## 8 SUMMARY OF POTENTIAL DS2 FAILURE MODES

## 8.1 DS2 Failure Mode Assessments

**Figure 8-1. DS2 Entry, Descent, and Impact Sequence with Potential Failure Modes**

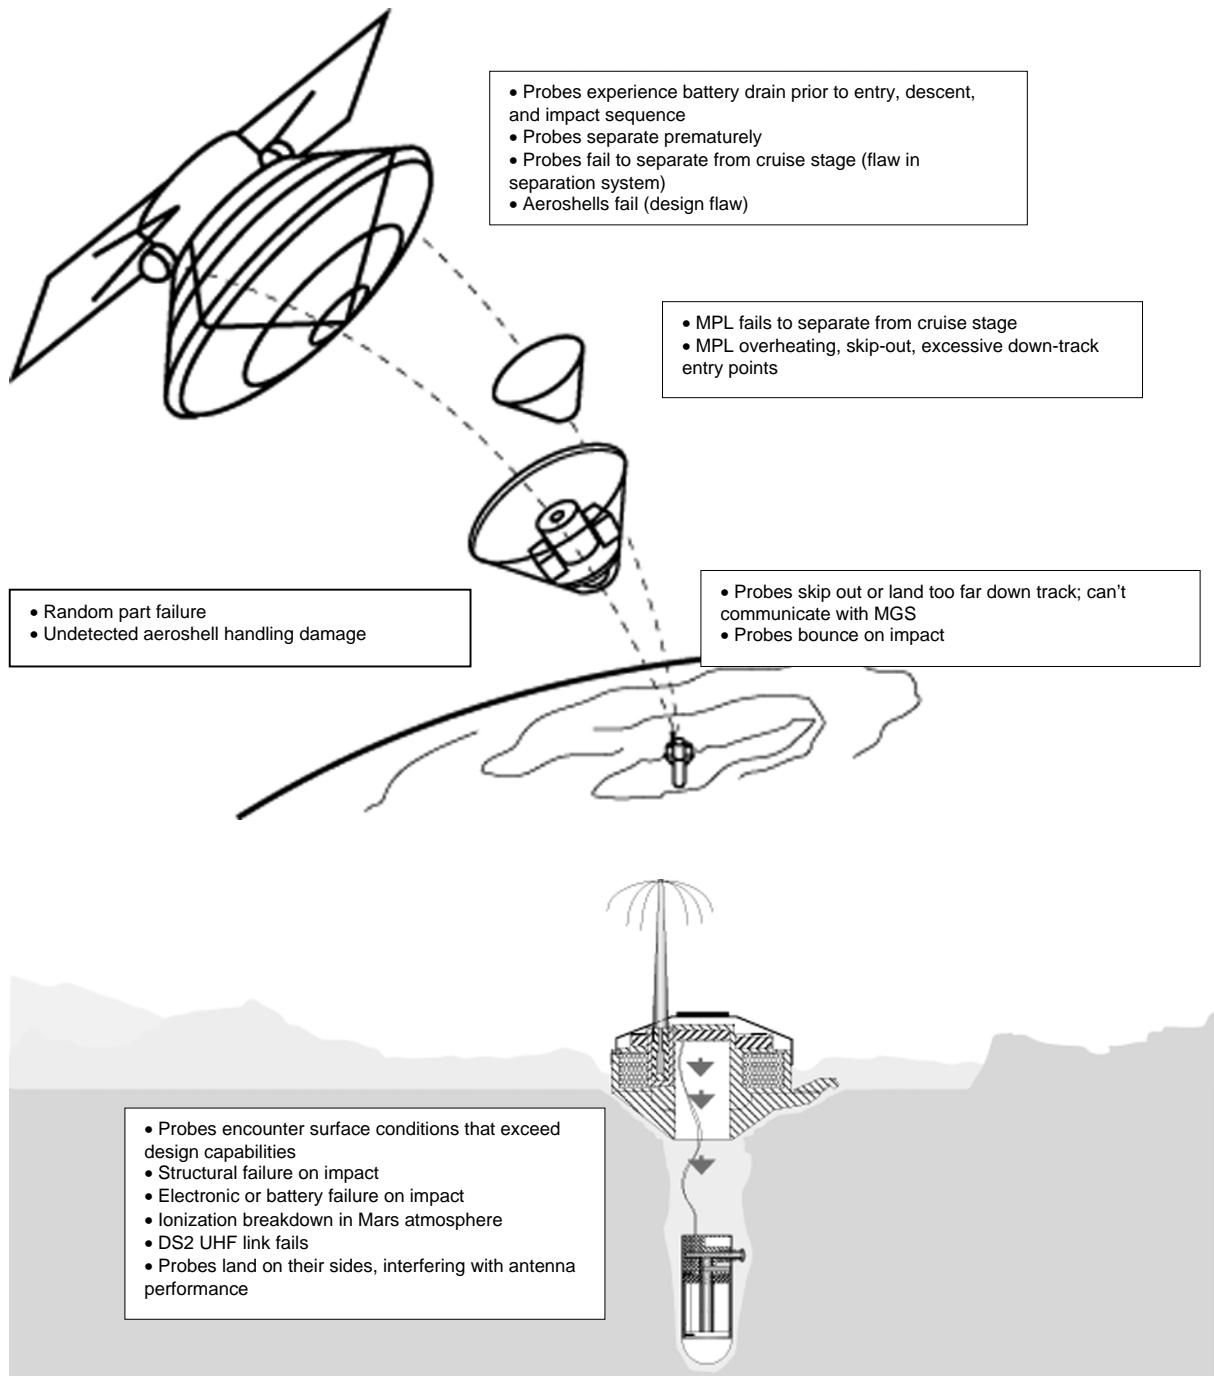
Failure Mode	Assessment
Both probes separate prematurely.	IMPLAUSIBLE. This failure mode is implausible during the launch environment prior to spacecraft separation from the launch vehicle because the probes would have impacted and damaged the cruise stage solar panels. There is no evidence of this in flight. Additionally, no plausible failure mode for premature separation of the probes after spacecraft separation has been identified. See Section 9.2.1.
Both probes experience battery drain prior to EDL due to: —Sneak path electrical transient, e.g., at launch vehicle separation —EMI effect, e.g., from Range or launch vehicle emitted radiation —Plasma discharge, e.g., from pyro firings	PLAUSIBLE BUT UNSUPPORTED. There are several design deficiencies associated with the probe power switch circuit. The most critical of these could result in inadvertent turn-on of the probe and premature battery depletion. Inadvertent probe activation did occur during the final hardware assembly activity but was discovered before significant battery depletion. Several mitigation steps were subsequently implemented to minimize the chance for reoccurrence during processing or after integration with the MPL cruise stage. Although it is believed that these mitigation steps were successful, the actual circuit deficiency could not be corrected. See Section 9.3.

Both probes fail to separate from cruise stage due to systematic flaw in the probe separation system.	IMPLAUSIBLE. Judged not plausible based on a review of the design and test program. See Section 9.2.3.
Aeroshells fail on both probes due to systematic flaw in the aeroshell design.	IMPLAUSIBLE. Judged not plausible based on a review of the design and test program. See Section 9.2.4.
Both probes skip out or land too far down track to be able to communicate with MGS due to atmospheric model errors, e.g., density lower than design range.	IMPLAUSIBLE. The penetrator shape (the critical aerodynamic design factor) was selected to be identical to the Viking and Pathfinder designs to take advantage of these well-established databases. Some updates to the Mars atmosphere database were made based on MGS data, and the modeling approach has been independently verified by LaRC.
<i>FLAG 1</i> Both probes bounce on impact due to unanticipated surface effects, e.g., lubrication effects of upper layer.	PLAUSIBLE. Probe impact on an ice surface was not a design requirement and not tested during development because this possibility was believed unlikely. This condition still seems unlikely, but cannot be ruled out. As another example, the MGS site survey suggests at least a few centimeters of soft material on top of whatever the underlying material may be. Since this soft material would support only a minimal shear force, it could act as a lubricant that would make penetration of any smooth hard underlying material less likely. See Section 9.1.2.

Both probes suffer structural failure at impact.	PLAUSIBLE BUT UNSUPPORTED. The probe aft-body, without the aeroshell, was empirically designed to withstand the impact tests. Due to lack of a suitable air gun, an impact test of the probe integrated with the aeroshell was never successfully conducted, preventing full characterization of the dynamic interaction between the aeroshell and the aft-body. The probe did survive the impact tests to which it was subjected. See Section 9.2.5.

Failure Mode	Assessment
<p><i>FLAG 2</i> Both probes suffer electronic or battery failure at impact.</p>	<p>PLAUSIBLE. The DS2 project implemented a qualification program whose goal was to mitigate the potentially destructive effect of probe impact with the Mars surface. This program concentrated on qualification of the design approach, associated processes, and critical devices using engineering or otherwise representative hardware. Testing was performed on the hardware in an unpowered state with inspection and functional testing (where possible) performed pre- and post-test. Survival of a particular process method or hardware element constituted acceptable qualification.</p> <p>More than 50 impact tests were performed per the above described incremental build–test strategy. It was fundamentally successful as a method for qualifying the design and assembly approaches, but was incomplete with respect to qualifying several of the key subsystems and components. In particular, qualification of the battery and RF system is not considered adequate. There was no system-level impact test of a flight-like RF subsystem. It was qualified, mechanically and structurally, with brassboard and breadboard components in most cases. Many of these components were not electrically functional and, therefore, only limited pre-test and post-test DC continuity checks could be performed.</p> <p>The battery test program was reasonably thorough but also inadequate to assure qualification. During the program, an evolutionary series of failures were experienced as part of the design and development effort. However, it does appear that the incremental build–test effort led to an acceptable final design. The flight battery cell lot was delivered very late and could not be impact tested. Instead, the flight units were qualified by similarity to a preceding lot of identical cells. During qualification of the preceding lot, one of eight cells experienced physical damage but did not fail catastrophically. The small sample size and observed damage lead to a concern that the flight cell lot was not fully qualified.</p> <p>At a higher level, impact qualification of a complete flight-like probe was not attempted due to cost and schedule constraints, and due to the fact that it is technically challenging. Therefore, the impact qualification program is judged successful at verifying the general technology approach but not with respect to the integrated probe design. See Sections 9.2.6 and 9.3.</p>

<p><i>FLAG 3</i> Probes fail due to ionization breakdown in Mars atmosphere.</p>	<p>PLAUSIBLE. The DS2 antenna uses umbrella-like whiskers on its end to increase the effective electrical length it to 1/4 wavelength. This type of antenna has a relatively high electric field potential at the end of the sharp antenna tips. The voltage generated at these tips could potentially exceed the ionization breakdown limit for CO<sub>2</sub> in the 6-torr Mars environment. The probe antenna was not tested for this environment. Therefore, it is possible that the antenna could experience breakdown when operated under such conditions. If breakdown did occur, the antenna performance would be degraded such that the uplink margin could be reduced below the threshold for communication. Until a test is performed, this failure mode is considered plausible. See Section 9.3.</p>

Failure Mode	Assessment
DS2 UHF link fails due to: —Beacon on MGS —DS2 transceiver —Incompatible protocol	PLAUSIBLE BUT UNSUPPORTED. Failure of any of the conditions listed would have precluded UHF communications between DS2 and MGS. The MGS to DS2 interface was simulated in a post-launch test with Stanford University in November 1996. Some of the 16 modes were verified during this test. The performance of the DS2 probes' Telecommunications Subsystem was tested in ATLO prior to delivery to KSC, but the probes could not be powered once installed on MPL until they were separated from the MPL cruise stage. A pre-launch test was performed between the flight spare telecommunications hardware and a CNES breadboard that verified the compatibility of the interface. See Section 9.4.1.
